PROJECT **123A90 - HOLLANDSE KUST NOORD WIND PARK**
BLPH Project

MECHANICAL COMPLETION DOSSIER (ONSHORE)

87-10-02

Junction Box 00-JE-11002 and Multi-core cable (PCS System)

C30002566

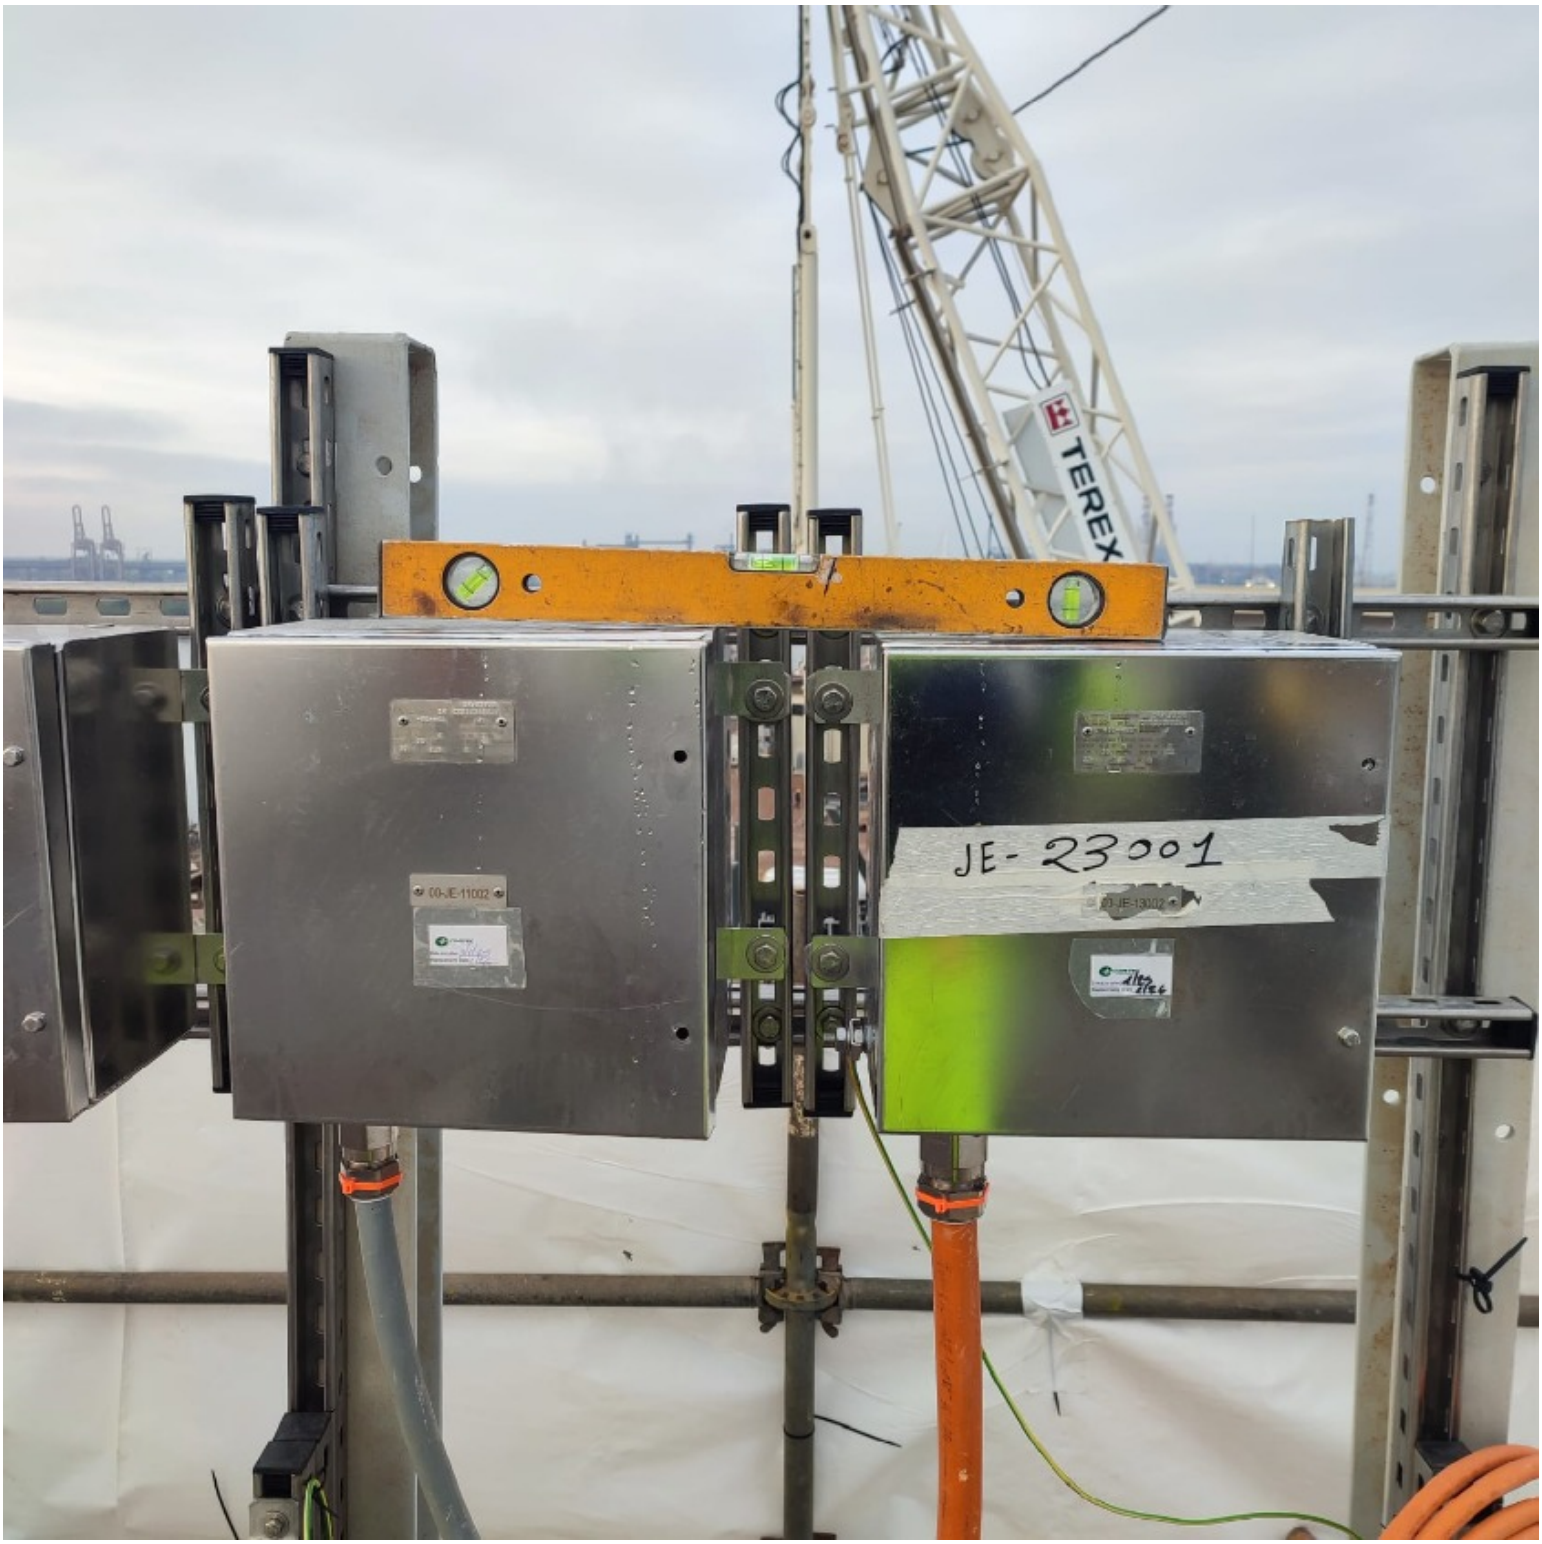
The position installation of JB is not in accordance with Layout.
See reference doc:123A90-FDL-IN-DL-40017 Rev, 1I.

See attached photo.

ENG declares that "Position indicated in doc. 123A90-DDL-IN-DD-40017 is indicative only"

C30002521

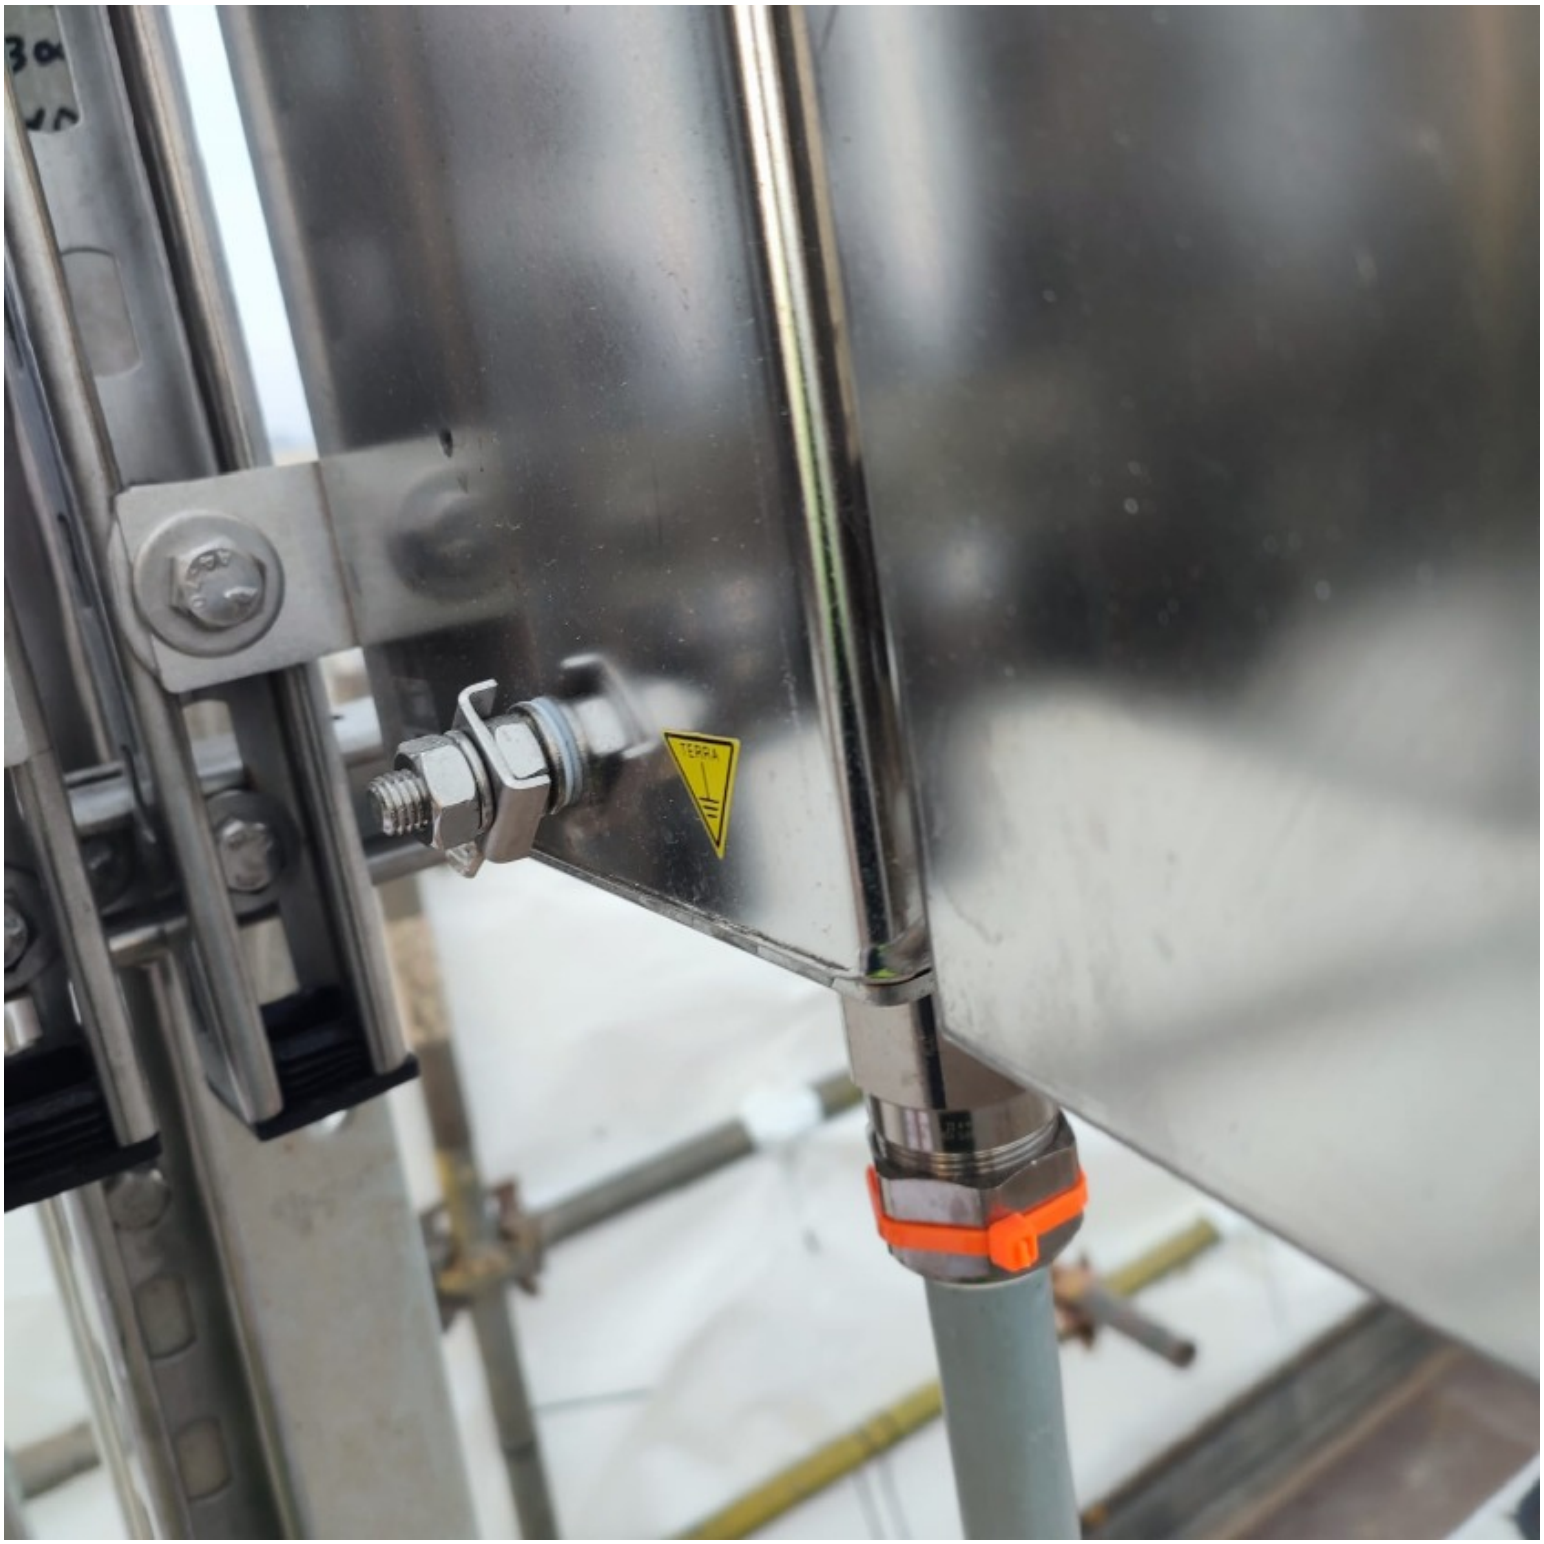
Missing earthing cable outside the JB. See attached photo.

DONE

C30002522

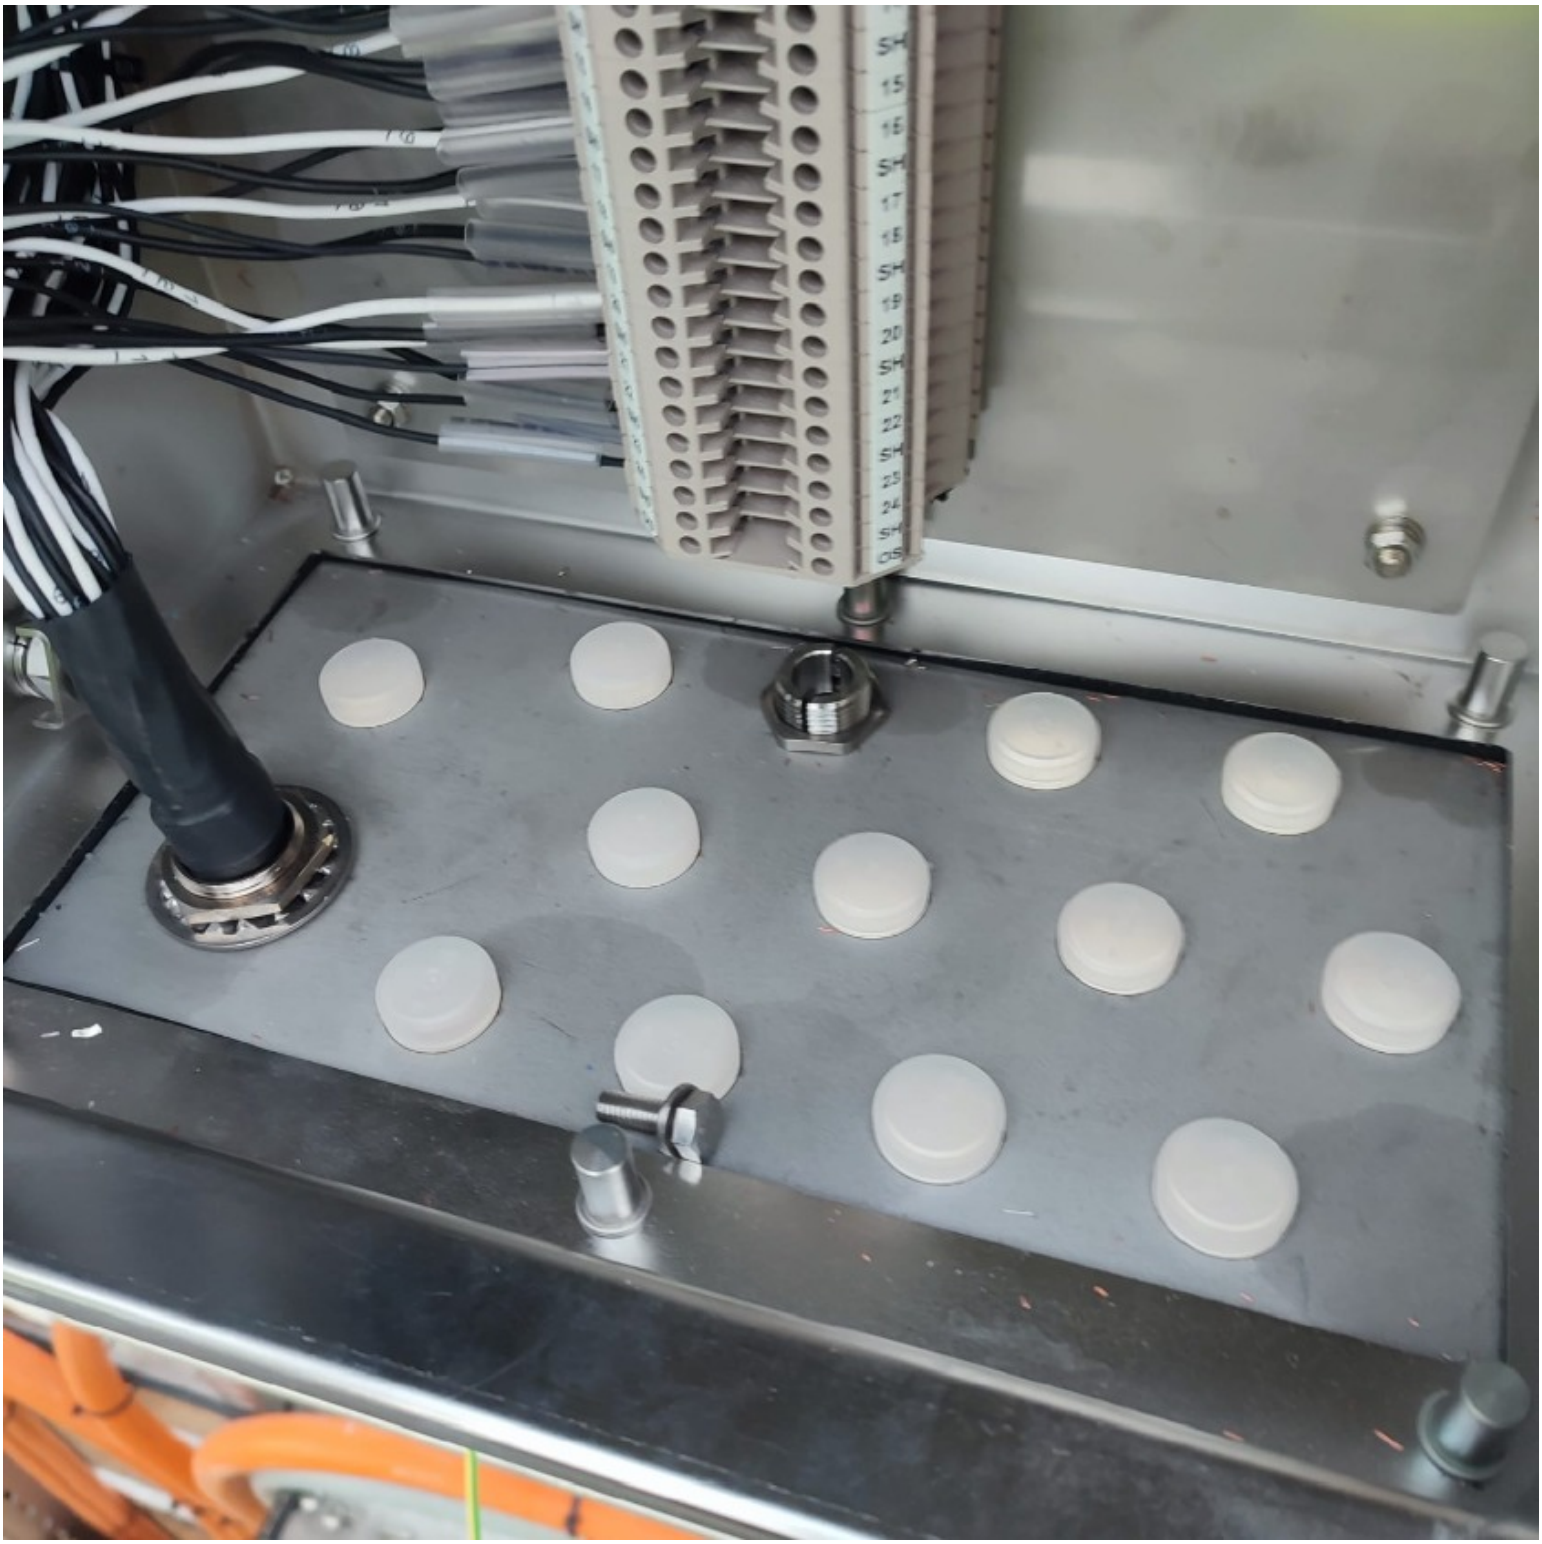
Missing certificate plugs inside the JB. See attached photo.

DONE

C30002529

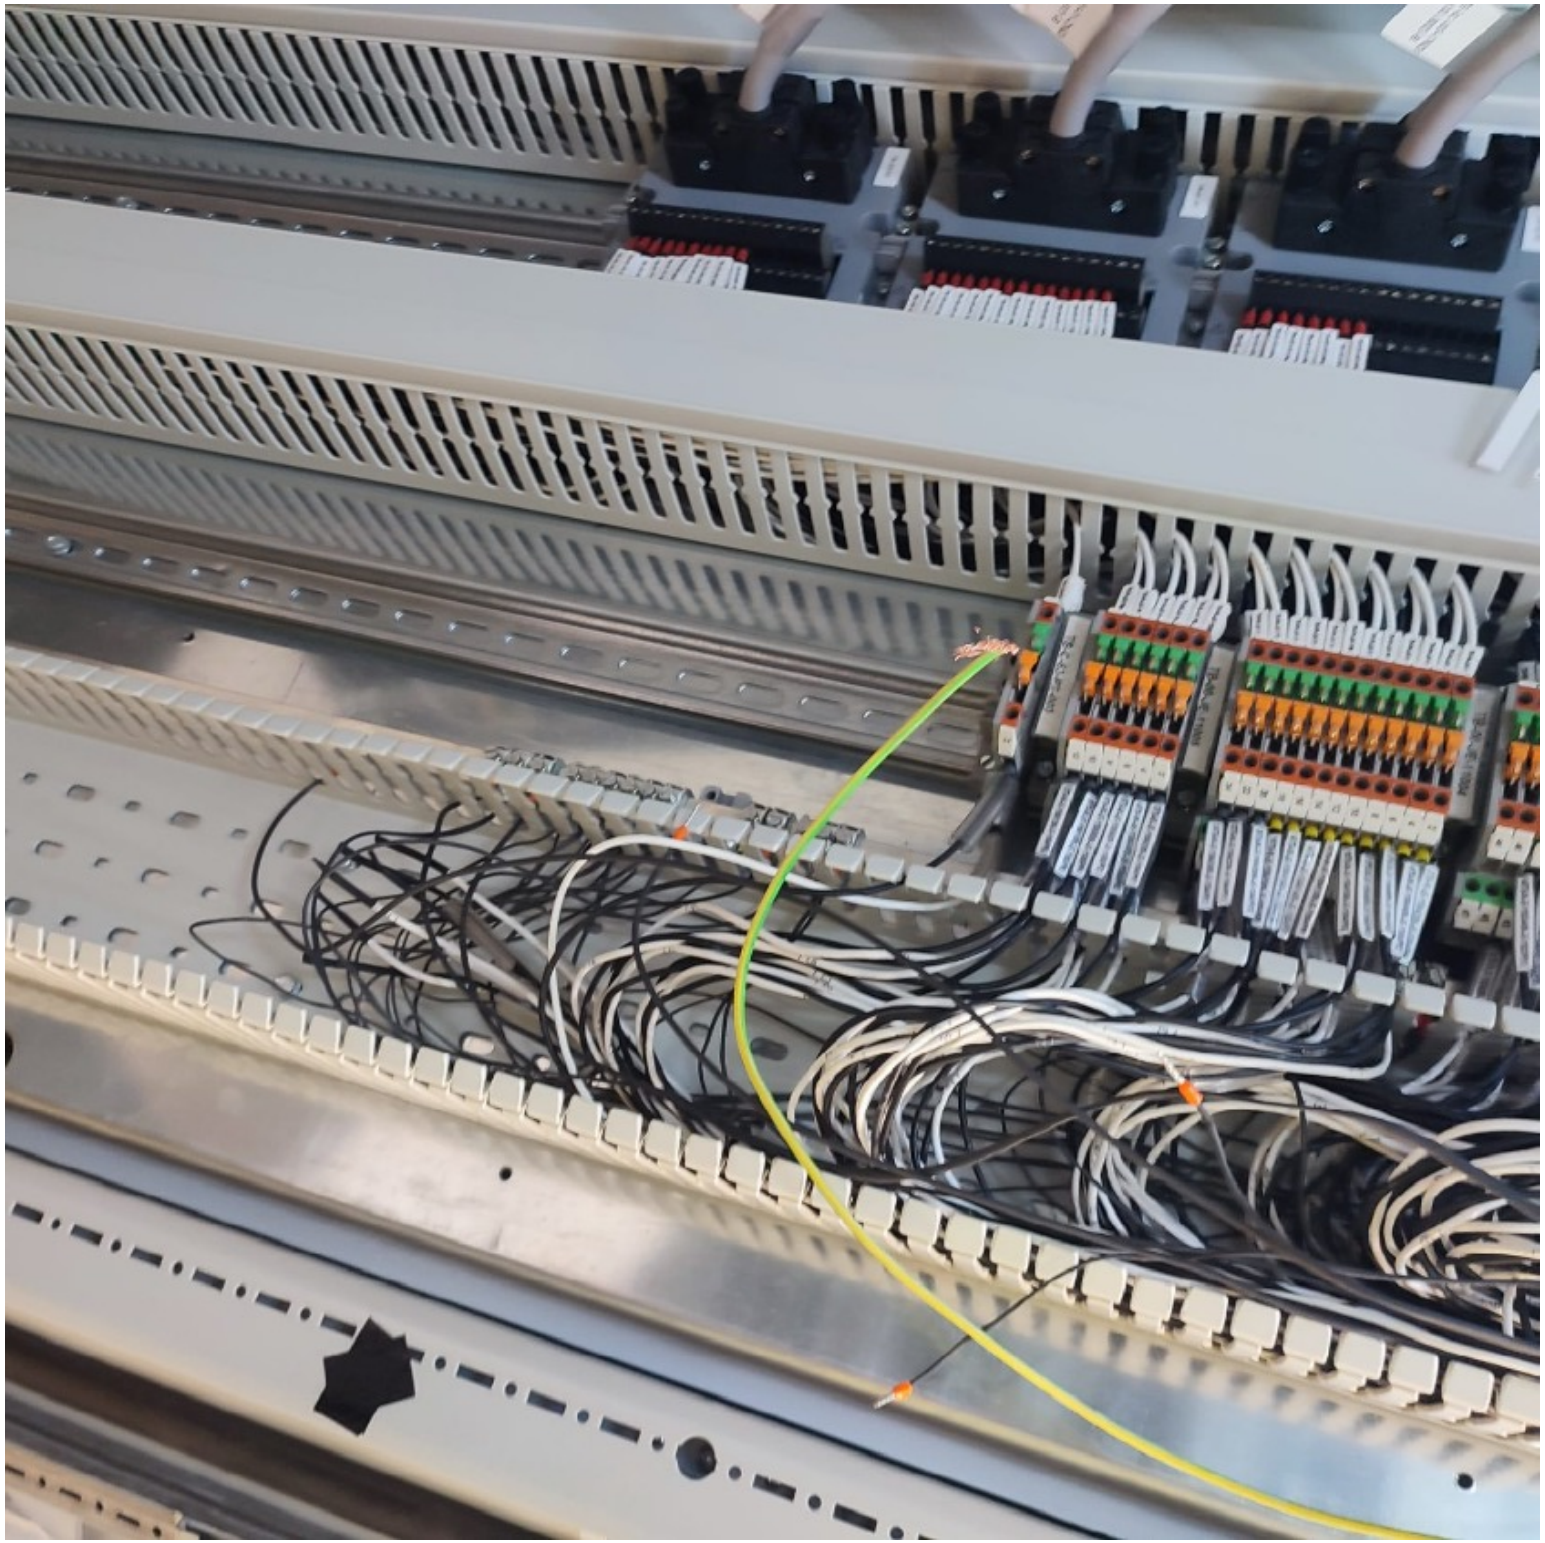
Partial shield as not connected on the terminal board. side the (B400-PCS-002).

See attached photo.

DONE
